CITY PLANNING COMMISSION

APPLICATION: A. Negative Declaration

C. Special Permit to allow the development of a 6,000 sq.ft. office building and a 62,000 sq.ft. office building in the Greenhaven Executive Park PUD

APPLC. NO. P88-164 **MEETING DATE** June 9, 1988 **ITEM NO** 18

SCALE 1" = 40'
PROPOSED SITE PLAN

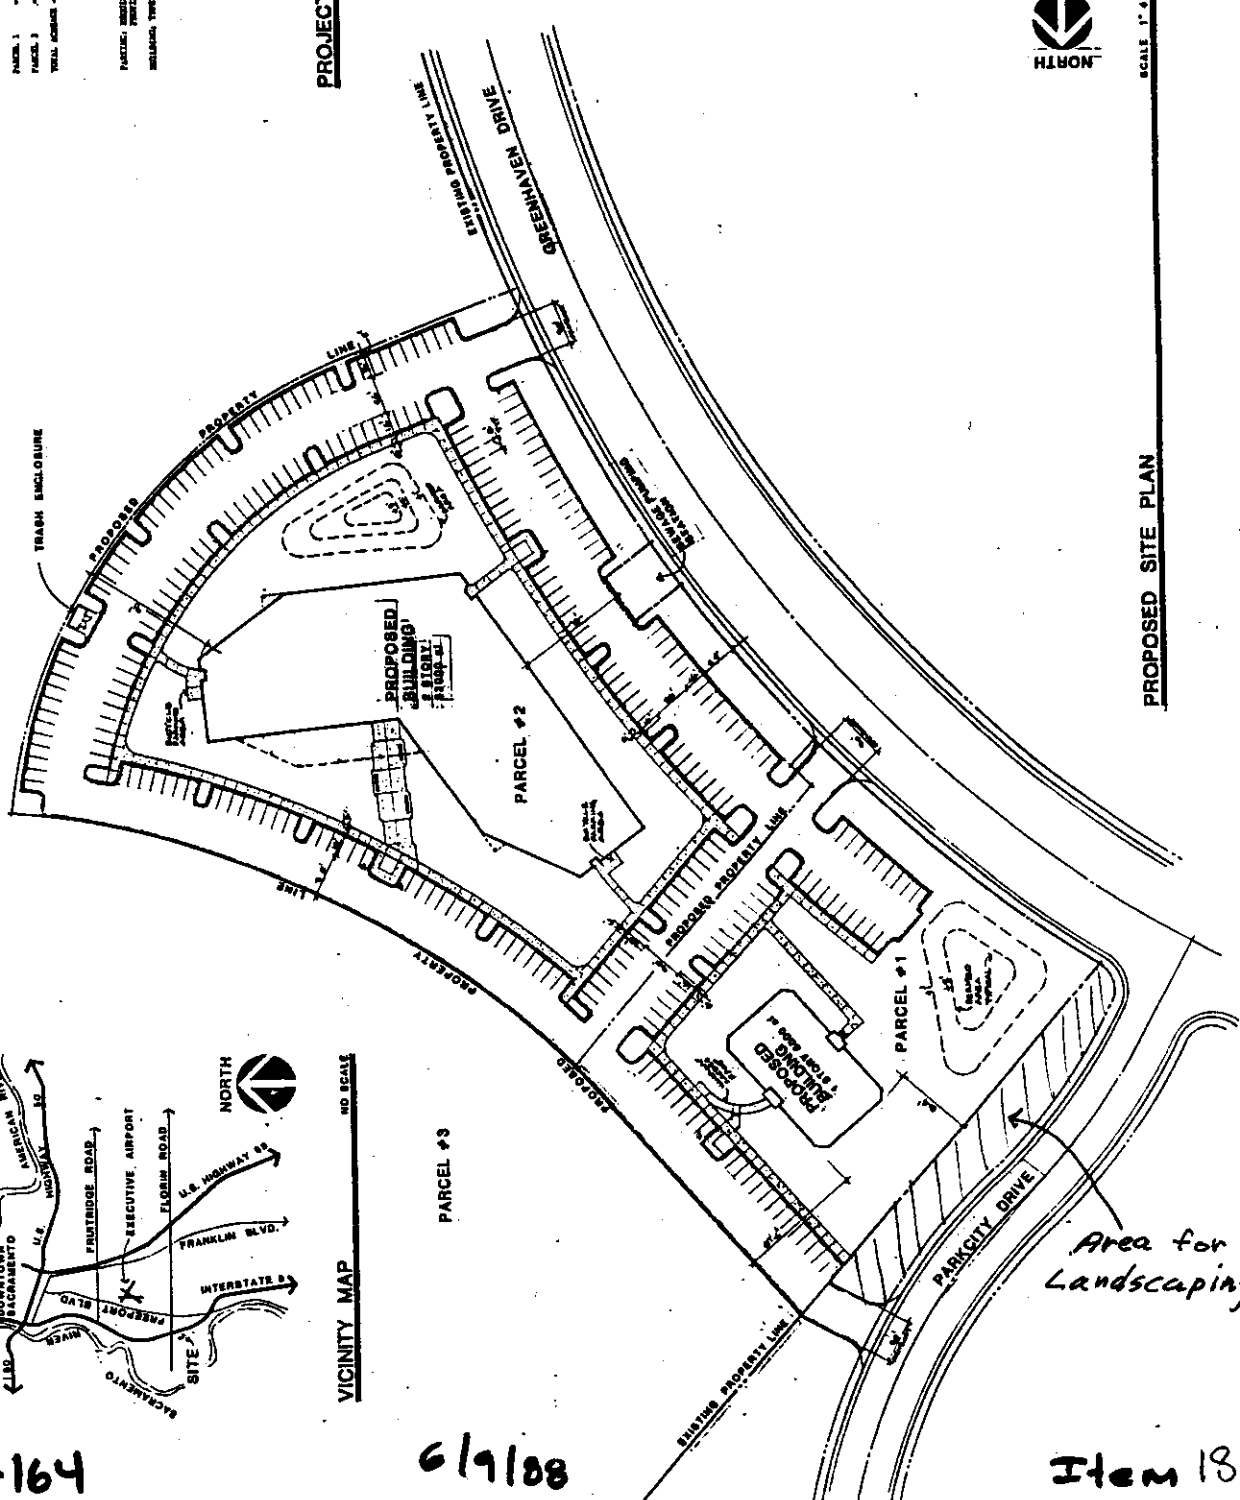
The parcel adjacent to the subject site along Park City Drive is of some concern to staff (see site plan). Staff recommends that the applicant either purchase the property or reach an agreement with the present owner to allow landscaping of this area.

The PUD guidelines require one parking space per 250 square feet for office development. Based on the 1:250 ratio and the 68,000 square footage total, 272 on-site parking spaces are required. The proposed site plan and the applicant's project application state that 272 parking spaces have been provided. However, a count of the spaces drawn on the site plan reveals 271 spaces. This discrepancy of one space should be cleared up by a minor revision of the site plan adding the additional required space. The driveway off of Park City Drive requires access across parcel 031-0051-09. The applicant must obtain a reciprocal access agreement from the property owner. Also, the applicant should provide reciprocal access to parcel 031-0620-009. The Traffic Engineer recommends the applicant dedicate Corporate Way to a 54' right-of-way and extend street south through the Executive Park and intersect with Greenhaven Drive to the satisfaction of the Traffic Engineer. This is consistent with the PUD schematic plan.

3. The parcel adjacent to the subject site along Park City Drive shall either be purchased by the applicant or the applicant shall arrange an agreement with the present owner to allow landscaping of this area.

4. The submitted site plan shall be revised to indicate the required 272 parking spaces and shall be reviewed and approved by the Planning Director prior to issuance of building permits.

ELEVATIONS

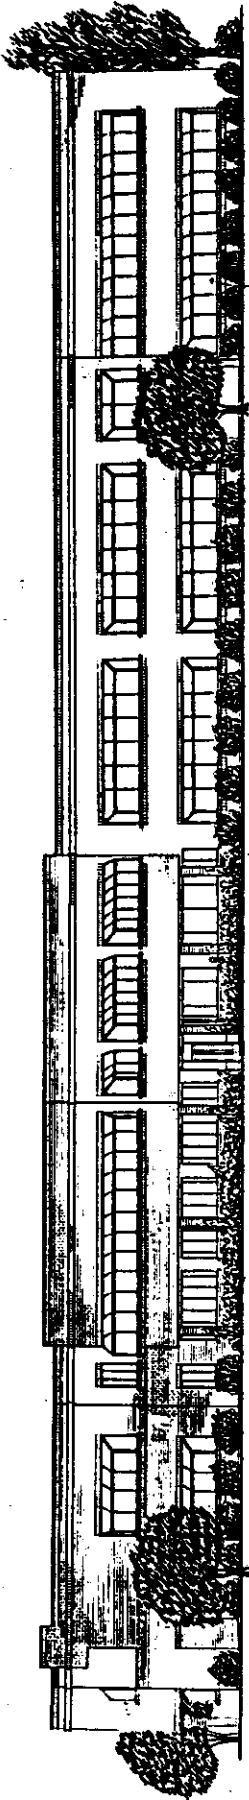
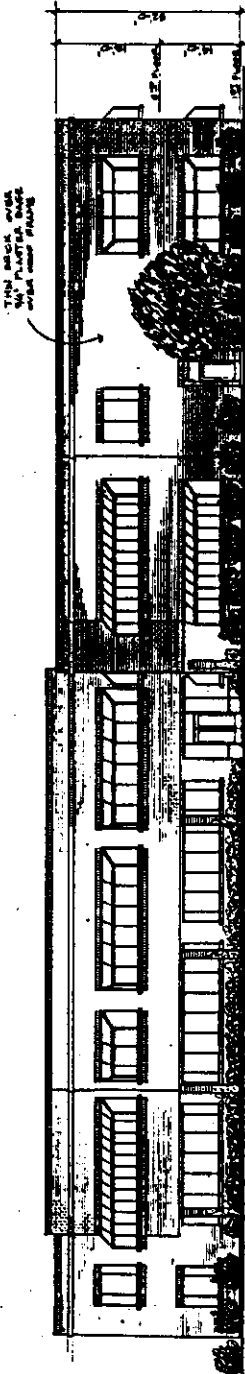
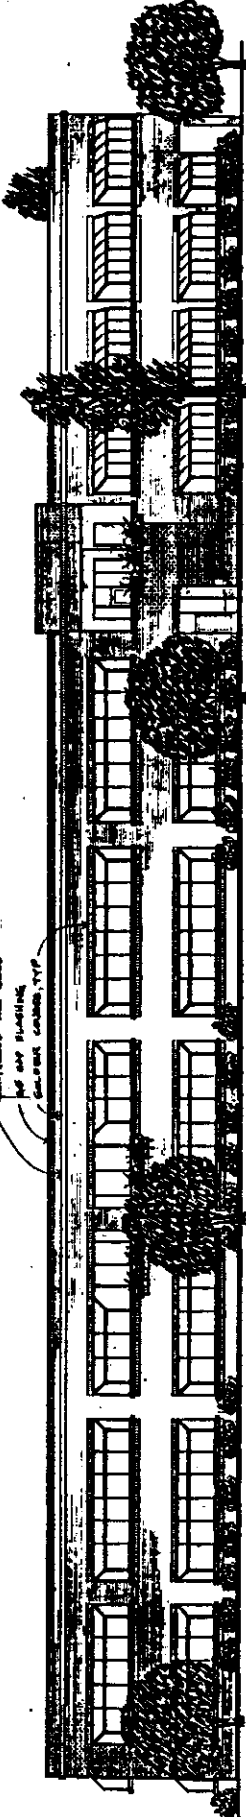
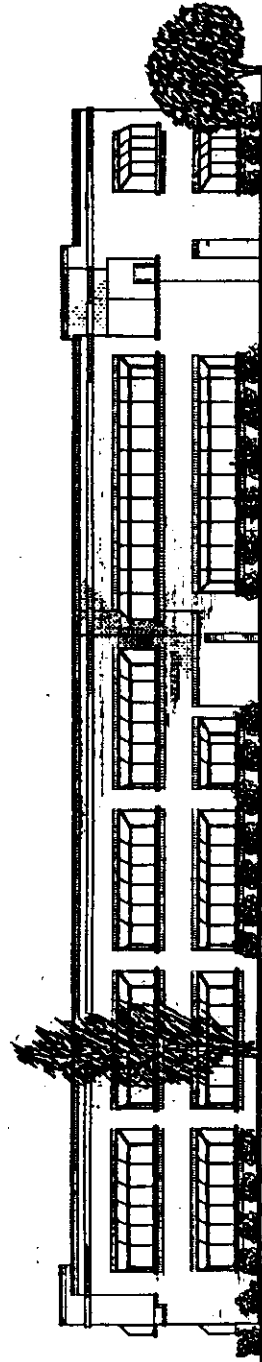
The submitted building elevations featuring brick with soldier courses and greenhouse-style windows are the result of several meetings with staff. The Design Review staff made various recommendations on design and building materials with specific modifications during the preliminary review for the project. The elevations now submitted conform to both the PUD guidelines and staff concerns with some minor exceptions. As previously mentioned, the building heights must be reduced from 32' to 30' in order to meet the requirements of the Executive Airport Overlay Zone. The applicant has indicated to staff that this modification can be achieved. The other revision refers to the one-story building. Staff recommends extending the width of the entrance area on the front elevation in order to give the entrance more definition. The entrance area should be extended from the proposed 12 foot width to 18 feet on the front elevation only.

9. The applicant shall revise the building elevations to reflect a maximum building height of 30 feet.
 10. The building elevation of the one-story building shall be revised to show an increase in the width of the entrance area from the present 12 feet to 18 feet.

11. The revised elevations shall be reviewed and approved by the Planning Director prior to the issuance of building permits.
 12. The applicant shall submit a sign program for review and approval by the Planning Director prior to issuance of sign permits.
